Xcel Energy

Information Request No. 4

Docket No.: IP-6985/WS-17-700

**Turbine ALT-4 Addition  
 Vestas V110/V120**

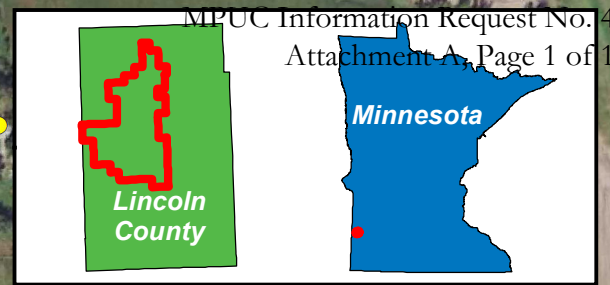
Explain the proposal for two collector lines to turbine Alt-4 or whether one is a proposed alternative. If both are proposed, please explain the need for two collector lines. Page 3 of 9, Summary of Environmental Impacts – Xcel Reply Comments:

The depiction of two collector lines is an error on the map. The northern alignment would be used as the collector line route, as shown in the attached, corrected map.
